RAI 03.07.02-25**QUESTION:****Follow-up Question to RAI 03.07.02-16 (STP-NRC-100036)**

RAI 03.07.02-26**QUESTION:****Follow-up Question to RAI 03.07.02-17 (STP-NRC-100035)**

RAI 03.07.02-27**QUESTION:****Follow-up to Question 03.07.02-19 (STP-NRC-100093)**

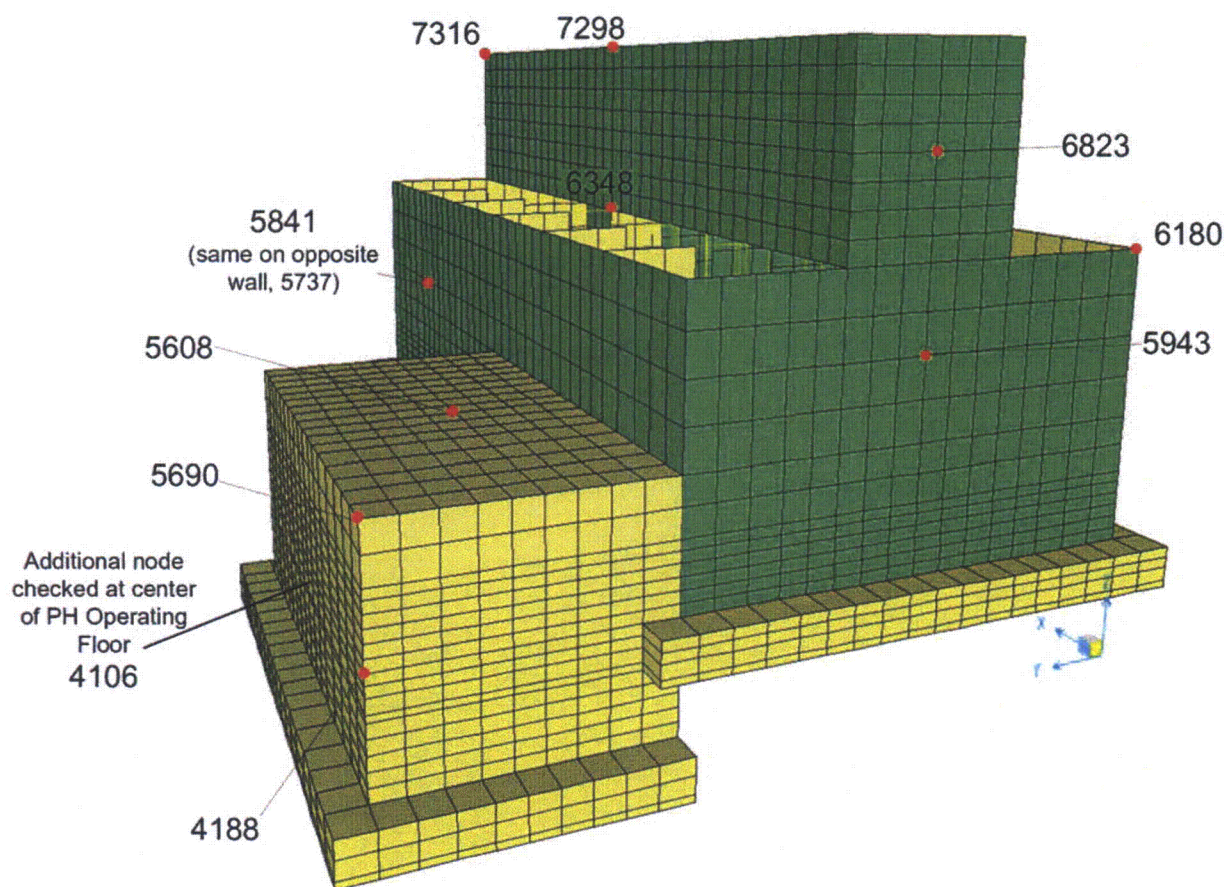
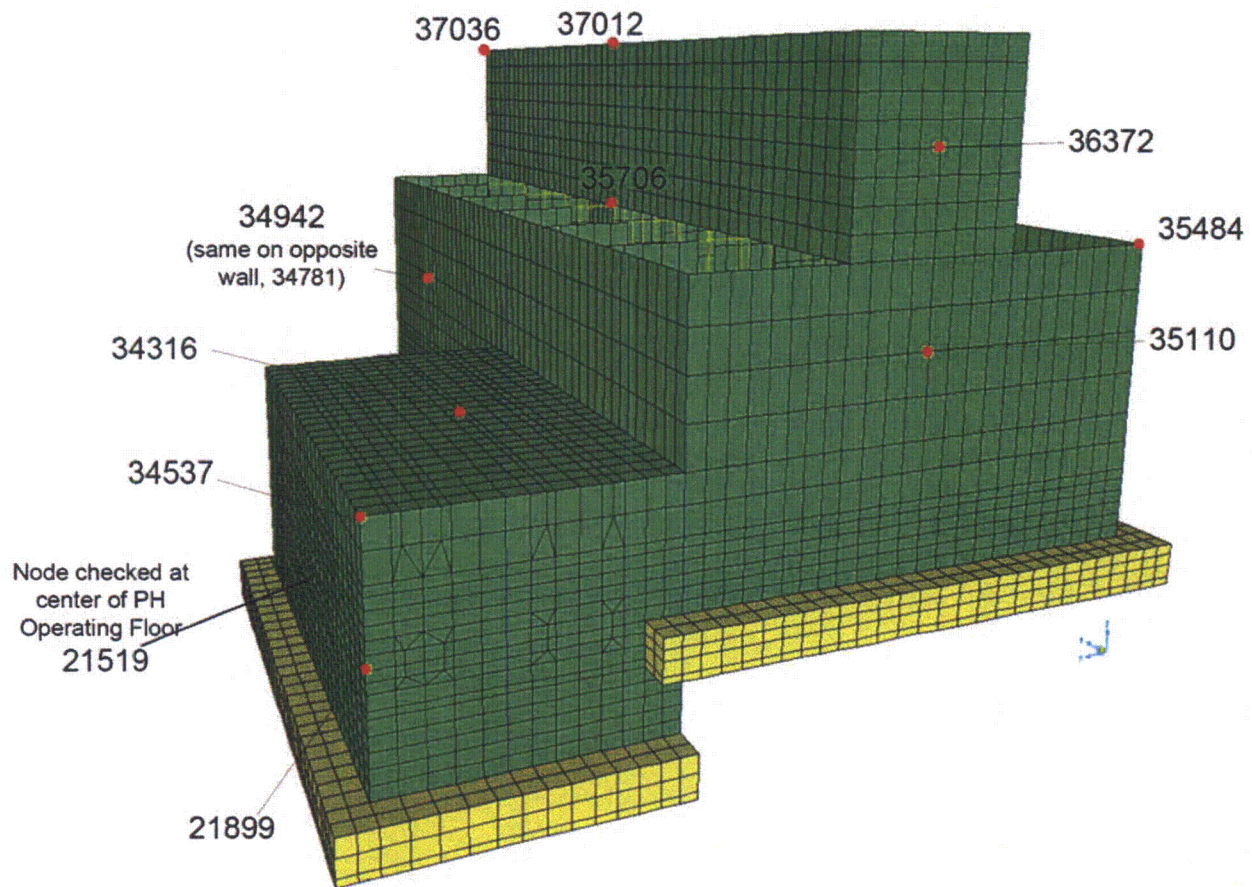
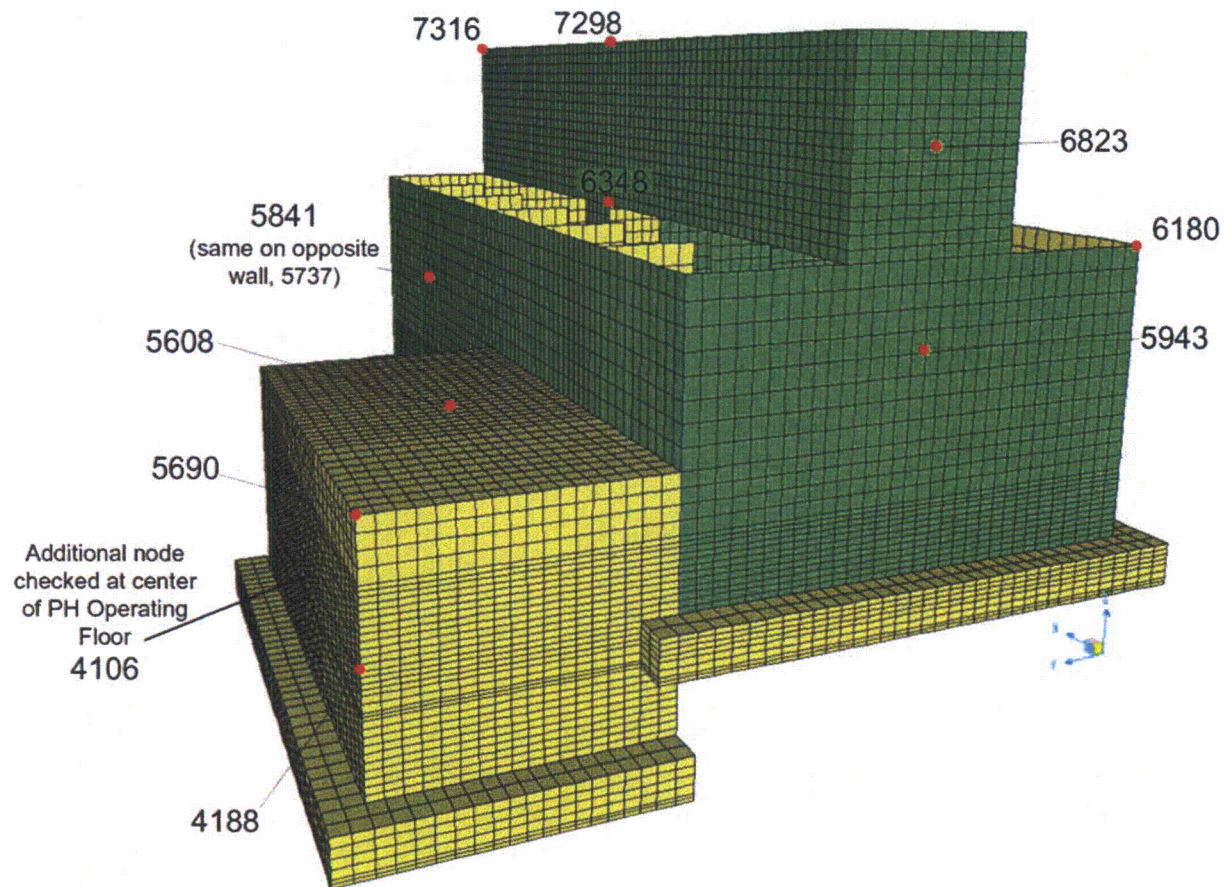
10CFR50, Appendix S requires that evaluation for SSE must take into account soil-structure interaction (SSI) effects. In the response to Item 1 of RAI 03.07.02-16 with regard to the adequacy of the structural mesh size used in the SSI analysis, the applicant has presented comparisons of the first two modes of the fixed-base structure in the E-W direction ($f_1 = 2.133$ and $f_2 = 2.056$ Hz) and N-S direction ($f_1 = 3.187$ and $f_2 = 3.028$ Hz) calculated using the SSI and design meshes. Although the comparisons of the two modes are good, they only represent a mass participation of about 17.1% and 15.4% for the E-W and N-S directions, respectively. In addition, the local modes are not reflected in these comparisons. As such, the applicant is requested to provide comparisons of the higher modes that include the out-of-plane modes of the slabs and walls to ensure the adequacy of the SSI mesh for transmitting frequencies of at least 33 Hz. This should include comparisons of in-structure response spectra of slabs, roofs and wall panels for the fixed-base structure calculated using the coarse SSI and fine design meshes subject to representative horizontal and vertical foundation motions. The staff needs this information to determine that the coarse mesh size (for modeling the structure) used in the SSI analysis is adequate for evaluation of SSI effect.

- Figures 03.07.02-25.1 thru 03.07.02-25.3 show original SSI model, refined SSI model, and refined structural model, respectively. Figures 03.07.02-25.6 thru 03.07.02-25.8 show Pump House roof to the same scale from the original SSI model, refined SSI model, and refined structural model, respectively.

- The node locations for comparison of in-structure response spectra are shown in Figures 03.07.02-25.1 thru 03.07.02-25.3 for the original SSI model, refined SSI model, and refined structural model, respectively. These locations include the Pump House Operating Floor, Pump House Roof, UHS Basin Walls, and UHS Cooling Tower Walls. The node locations for comparison of maximum accelerations, in addition to those locations for comparison of in-structure response spectra, include those shown in Figures 03.07.02-25.4 and 03.07.02-25.5.

Figure 3H.3-50: SSI and SSSI Lateral Seismic Soil Pressures (psf) on Radwaste Building East Wall

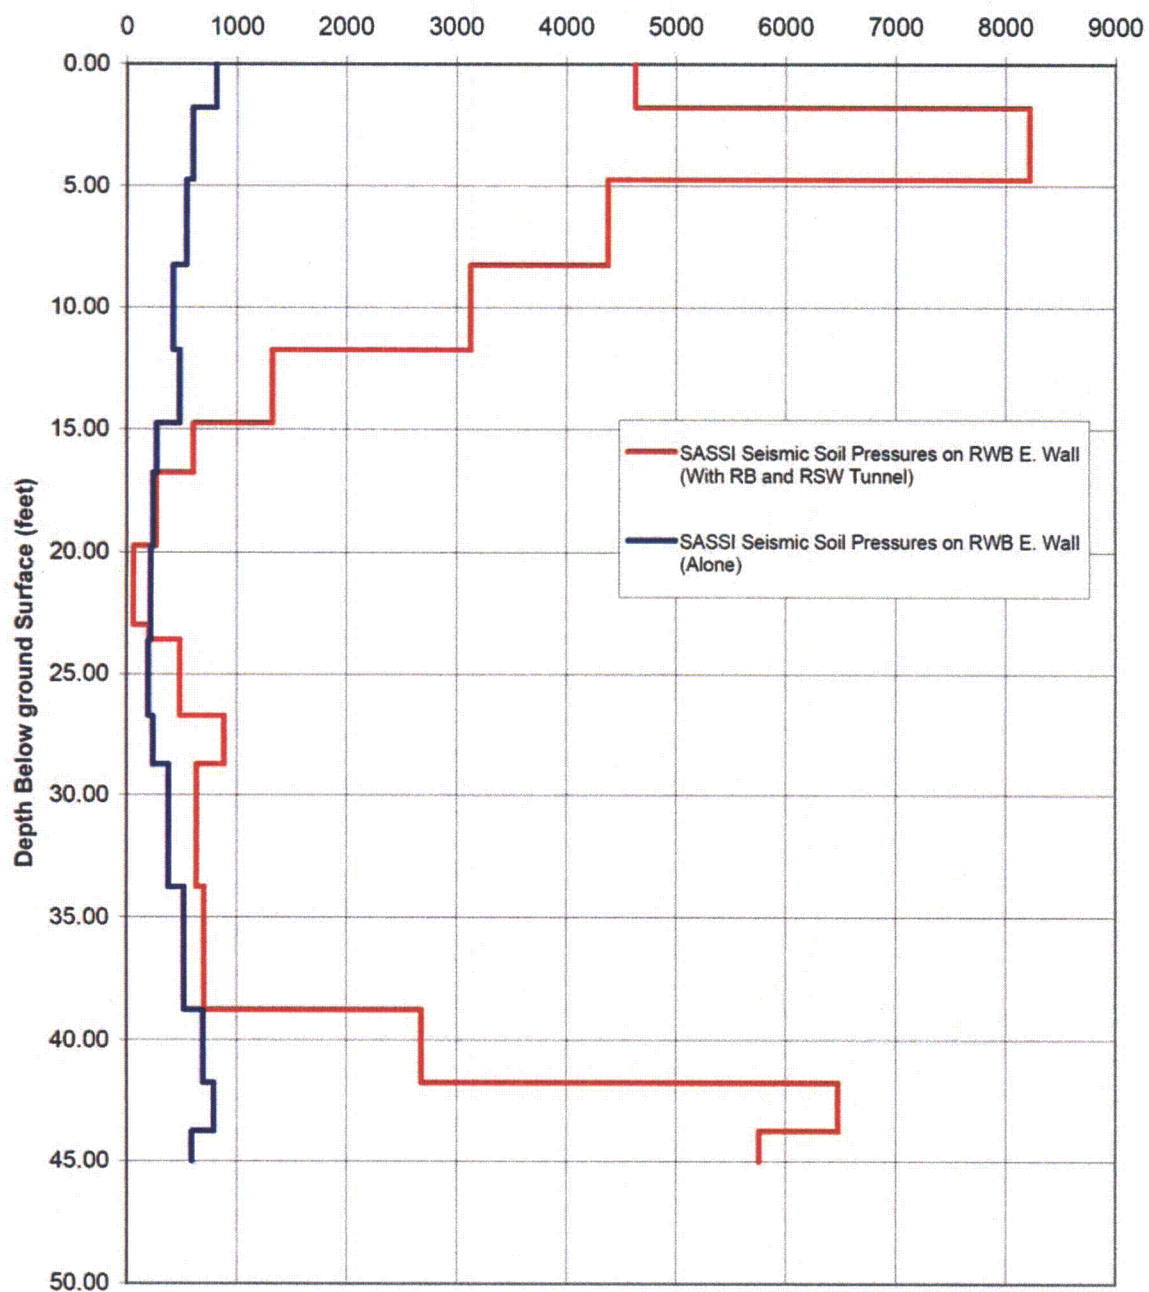
The COLA markup provided in the response to RAI 03.07.02-19, Revision 1 describes the procedure for establishing the SSE input at the foundation level of the RWB. According to this procedure, five interaction nodes at the depth corresponding to the bottom elevation of the RWB foundation will be added to the 3-D SSI model of the Reactor Building (RB). These five nodes correspond to the four corners and the center of the RWB foundation. The RB SSI model is analyzed for the STP site-specific SSE. The envelop of the resulting response spectra at the foundation level of the RWB (based on the average of responses at the 5 nodes) and 0.3g Regulatory Guide 1.60 response spectra will be used as the design response spectra for II/I evaluation of the RWB. This procedure for estimating the foundation input motion for the seismic SSI response analysis of non-Category I structures is acceptable. However, the procedure does not address the potential increase in dynamic soil pressures on the exterior walls of RWB due to the SSSI effects. The applicant is requested to describe how the increase in dynamic soil pressures on the RWB walls due to the SSSI effects will be accounted for in the design of the RWB exterior walls. The staff needs this information to ensure that the RWB exterior walls are adequately designed to maintain its structural integrity during a SSE in controlling any potential release of radioactive materials to the environment.

The resulting seismic soil pressures on the east and west walls of the RWB from the SSSI analysis are shown in Figures 3H.3-50 and 3H.3-51 in Enclosure 1, respectively.

The RWB east and west walls have been evaluated considering the SSSI seismic soil pressures in Figures 3H.3-50 and 3H.3-51. The evaluation confirmed that the existing design as reported in response to RAI 03.08.04-18, Revision 1, (submitted with letter U7-C-STP-NRC-100124 dated June 2, 2010) is adequate.

The RWB east and west walls are also designed for lateral seismic soil pressures shown in Figures 3H.3-50 and 3H.3-51, respectively. These soil pressures consider the structure-soil-structure interaction (SSSI) between the RWB, RSW piping Tunnel, and RB. For details of this SSSI analysis, see Section 3H.6.5.3.
